## Technical Memorandum

**Prepared for:** The Clean Air Coalition of Western New York  
Chris Murawski, Executive Director

**Prepared by:** Thomas J. Morahan, P.G.  
New York State Professional  
Geological Services PLLC

## Review of Remedial Investigation and Alternatives Analysis Reports for the Former Tonawanda Coke Facility Production Areas - Riverview Innovation & Technology Campus Brownfield Cleanup Program Site No. C915353 Tonawanda, New York

### **Comment 1 - Conceptual Site Model Dilemma**

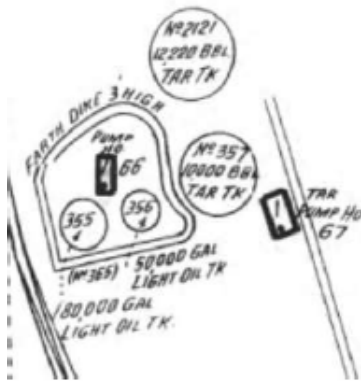
The Conceptual Site Model for the BCP facility is woefully inadequate as it does not address off-site impacts from upgradient sites such as Superfund Site 110 or to downgradient sites such as the Huntley Ash Fill and Site 109. Breaking this facility, related adjacent facilities such as Allied to the southwest, and historically compromised parcels such as the former wastewater discharge to the Niagara River into separate parcels does not allow for a comprehensive understanding of the mechanics of the environmental system.

Recommendation: In the future, NYSDEC should mandate more comprehensive site review strategies that allow for properly developed conceptual site models on which more comprehensive investigations can be based. Further, as evidenced by the volume of comments to the BCP Work Plan and the lack of understanding of actual byproduct locations and management locations not present in it, NYSDEC should require every BCP Application to contain an ASTM-compliant Phase I prior to the approval of the application, or, at a minimum as a prerequisite to be submitted with the work plan. In addition, some have suggested at least some sort of accompanying Environmental Impact Statement for larger projects such as those contemplated at this site.

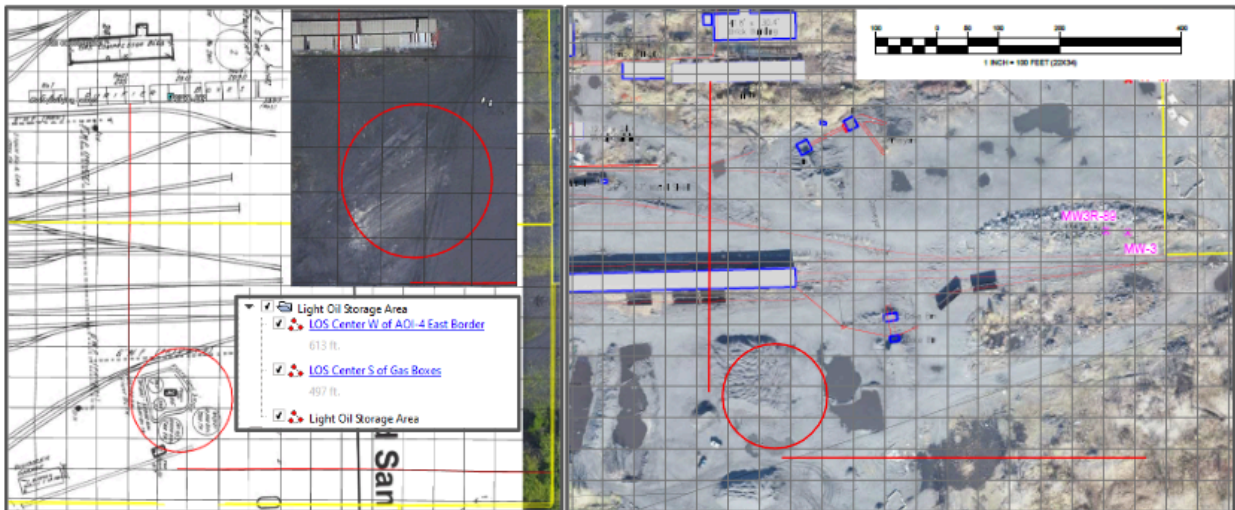
The Sanborn map in the nygeology ESA clearly showed the Light Oil Storage area. Although this area was vacant at the time of the investigation, the earthen diked area contained a 180,000 gallon Light Oil Tank as well as a 50,000 gallon Light Oil Tank and a pump house as shown below.

Outside the diked area were 12,200 barrel and 10,000 barrel tar tanks as well as a tar pump house. Figure 2-1 in the RIR shows the center of the area in the vicinity of Block AL-18.

Figure 2-17 in the RIR, shown above, shows no soil sampling in this location. Because figures in the RIR do not clearly label each byproduct management area contained in the digital file submitted with the 2020 Work Plan comments, it is difficult to tell whether samples were collected in each location identified as an REC in the ESA.

Require a byproduct overlay map and ensure that each REC was properly investigated. While such an exercise may not affect the choice of remedy in the AAR, it would ensure that remedial design engineers do not miss contamination. After the public comment period closes, Clean Air would like to reserve the right to take time to compare the work performed to each REC identified in the ESA and present the results to NYSDEC, and the site engineer at a meeting to ensure completeness of the RIR.

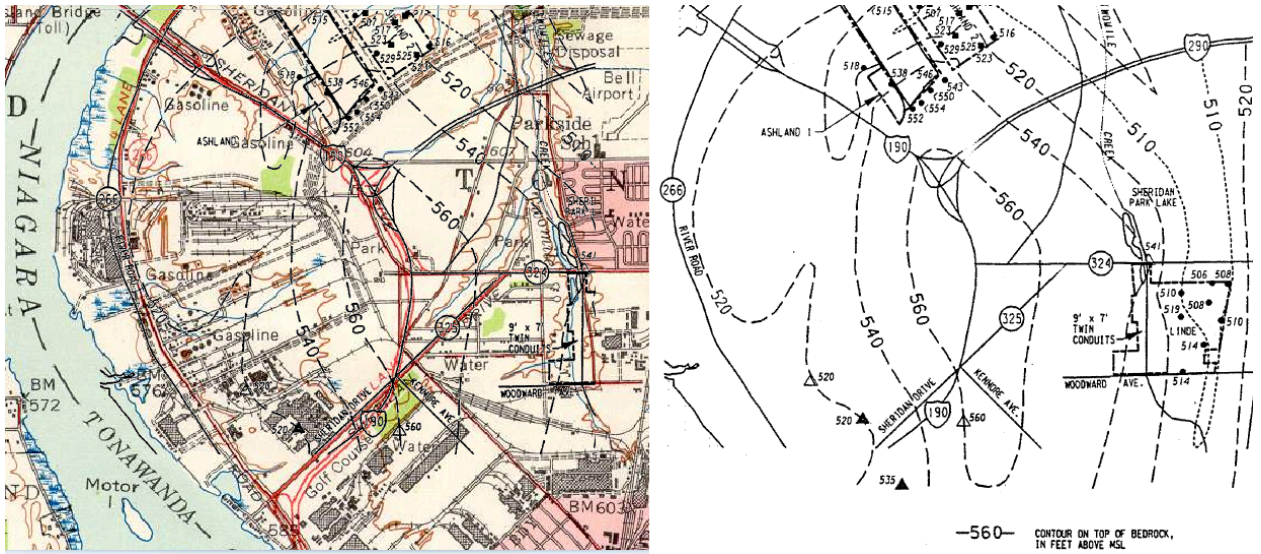
*Site 110* - RIR flow maps, presented below, show that shallow groundwater in the fill flows west from Site 110 toward the BCP Site suggesting the possibility for a future upgradient source, particularly if Site 110 receives hazardous waste as part of the remedy for Site 109.

*Regional Groundwater Flow* - The 1993 USDOE Remedial Investigation Report for a Tonawanda Site discussed in the hydrogeology ESA shows a Camillus Formation upper bedrock aquifer at the Tonawanda Coke sites. Of particular interest, hydrogeology noted that the "two

heads of bedrock valleys seen in the 520-ft elevation contour, one approaching the BCP Property from the south, the other from the north. These features would be expected to favor southward flow in the aquifer beneath the southern part of the Property which is the flow regime reflected in the Inventum RIR. An illustration from the nrygeology RI Work Plan Public Comments is presented below for completeness:

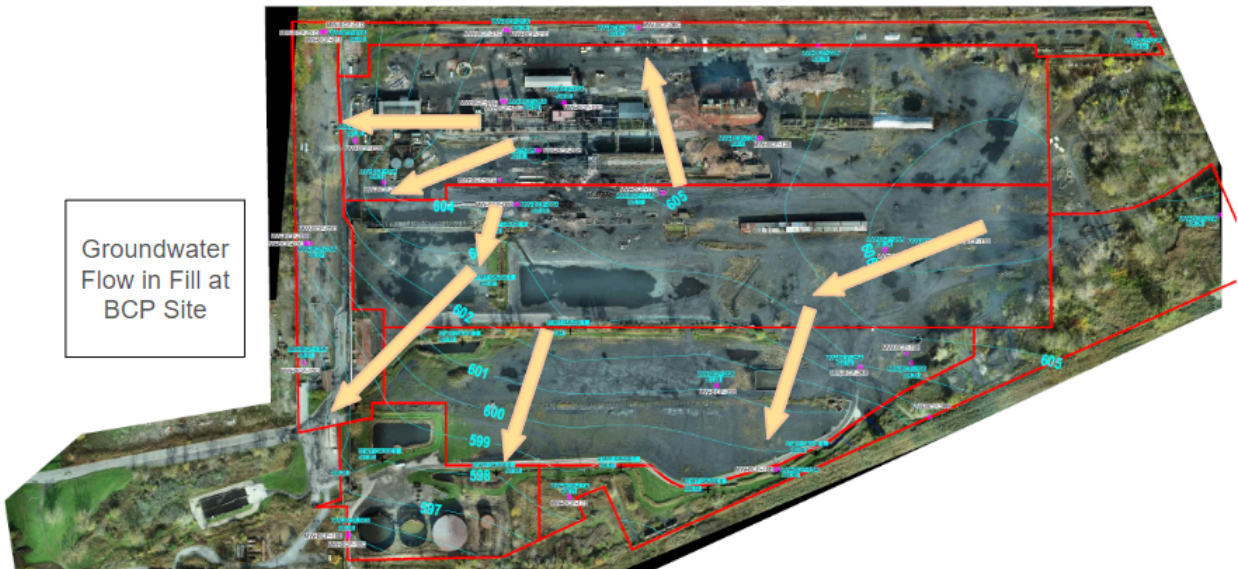
*Groundwater Flow in Fill* - The RIR figure illustrated below shows groundwater flow in fill at the BCP site; it shows groundwater mounding in the fill with flow components to the north, west and south. While some contamination in the production area would be expected to flow south, other flow components could direct contamination north across the property boundary toward the Huntley Ash Fill Site or southwest toward Site 109.

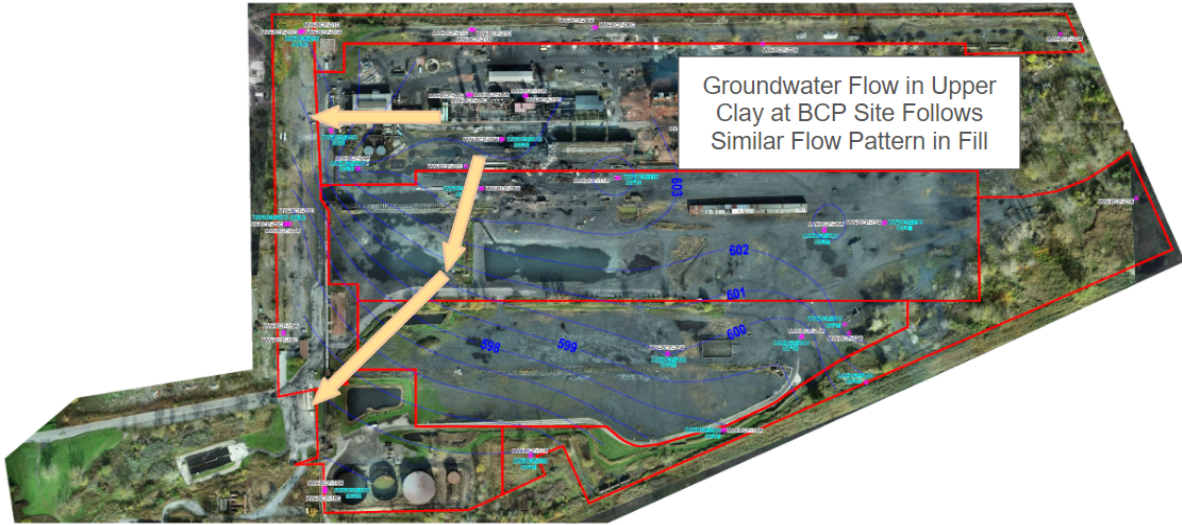
*Groundwater Flow in Clay* - Generally, the groundwater flow in the fill generally follows the top of the clay layer to the southwest, and groundwater flow in the Upper and Lower Clay Units follow the same pattern. Following the groundwater flow path from the major contaminant source locations in the production areas at the BCP Site and noting the relatively high level of the contamination of the fill in these areas, the presence of contaminants in the clay water-bearing zone was examined to uncover whether the clay zone had been contaminated. In particular, some of the exceedances of class GA groundwater standards in the upper clay included:

- AOI-1 Phenol, Chromium, and Arsenic
- AOI-2 Chromium, and Arsenic
- AOI-4 Volatile and Semivolatile Organic Compounds, Chromium, Arsenic and Mercury
- AOI-5 Volatile and Semivolatile Organic Compounds, Chromium, Arsenic and Ammonia
- AOI-7 Volatile and Semivolatile Organic Compounds

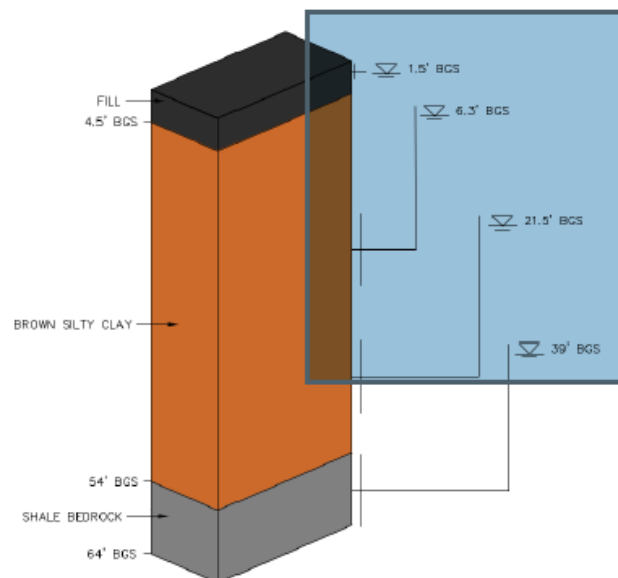
The lower horizontal gradients present in the fill and the bedrock and the horizontal gradients one to two orders of magnitude higher in the combined clay unit suggest that the examination of vertical heads between the fill and the clay and the clay and the bedrock need to be considered. Data showing vertical heads in hydrogeological units at the Tonawanda Coke BCP Site were provided in the following figure in the RIR:

The vertical gradient across the clay was calculated from the above figure to be 0.758 in the downward direction, orders of magnitude greater than any horizontal gradients measured at the site. Using the thickness reported above, this could result in a flow of 0.79 feet per year in a downward direction. The lack of contamination in a downgradient direction at this time could be the direct result the low permeability of the clay, however, given the approximate dates of likely releases during facility operations, and, given the current contaminant distribution in the clay unit, contaminants could be expected to enter the bedrock flow regime. Therefore contaminant transport could look like this downward through the clay unit at some point in the future:

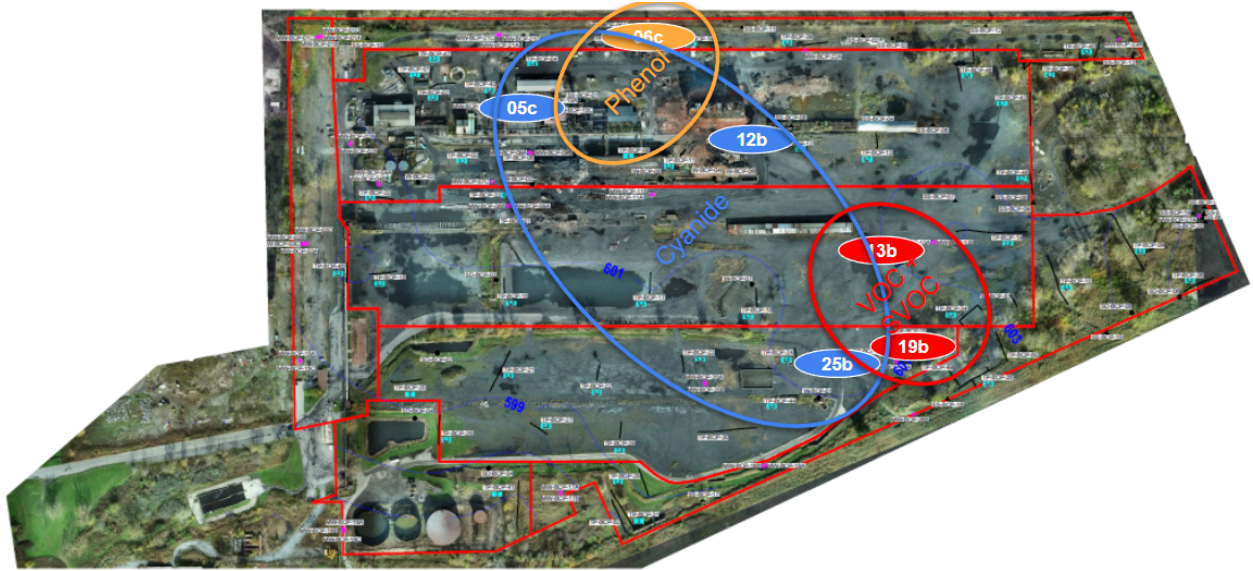
To try to evaluate potential leakage from the fill through the clay, groundwater results from the wells screened in the clay units in Areas of Interest (AOIs) were examined for detections of Cyanide, Phenols, Volatile Organic Compounds and Semivolatile Organic Compounds as anthropogenic indicators of leakage. Exceedances of metals were not used to avoid confusion as they could be naturally occurring. Results of the analysis are summarized below from the figures in Volume 2 of the RIR.

AOI	Well	Screen	Clay Unit	Compounds	RIR Figure
2 West	06c	30-40	lower	Phenol	4-8
2 West	05c	29-39	lower	Cyanide	4-13
2 East	12b	12-25	upper	Cyanide	4-18
4 East	13b	20-30	upper	VOC, SVOC*	4-32
5 East	19b	10-20	upper	VOC, SVOC*	4-38
5 East	25b	14-24	upper	Cyanide	4-38
7 West	17b	10-20	upper	Acetone**	4-50

Results clearly show some migration of contaminants into the clay units.

In AOI 2 West, some contaminants have migrated to wells screened around 30 to 40 feet deep. Taking an average contaminant depth of 35 feet with an average fill thickness of about 5 feet means that some contaminants could have migrated 30 feet down from the fill into the clay.

In addition, the presence of high levels of VOCs and SVOCs shown in the above figure may also have two explanations. One regards the lack of investigation at the Light Oil Storage Area; although that area should technically be downgradient of the affected wells, it is possible that the contamination could be due to releases during rail offloading events. Another explanation is that this area is downgradient of Site 110.

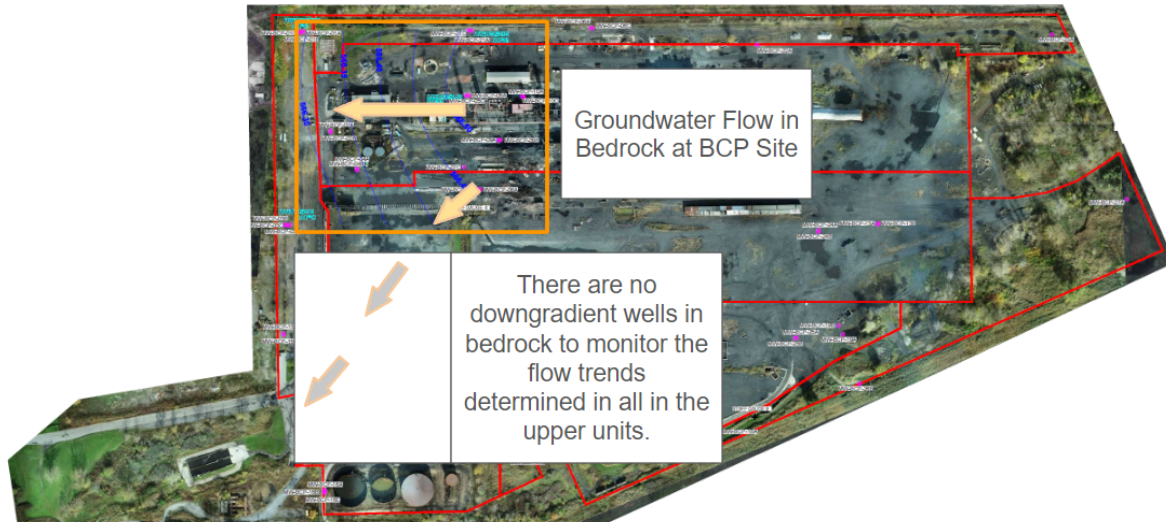
*Groundwater Flow in Bedrock* - As shown below, a total of four bedrock wells were drilled and used to construct the groundwater flow map in bedrock. Given the locations and lack of sufficient bedrock wells precludes the measurement for flow in the south and southwest direction as suggested by previous studies.

**Recommendations:** Work should be considered to determine the source of contamination in the clay zone near the production area and whether that monitoring network is adequate. In addition, work should also be done to determine the level of contamination in the Light Oil Storage area and whether it is related to Site 110. In any event, downgradient monitoring of a potential transgressing contaminant plume from the BCP Site to Site 109 will be necessary.

Given the above analysis that bedrock contamination could be expected in the future, additional nested wells should be considered to the southwest upgradient of Site 109 into clay and bedrock units to monitor for the potential downgradient off-site transgression of groundwater contamination from the BCP site to Site 109.
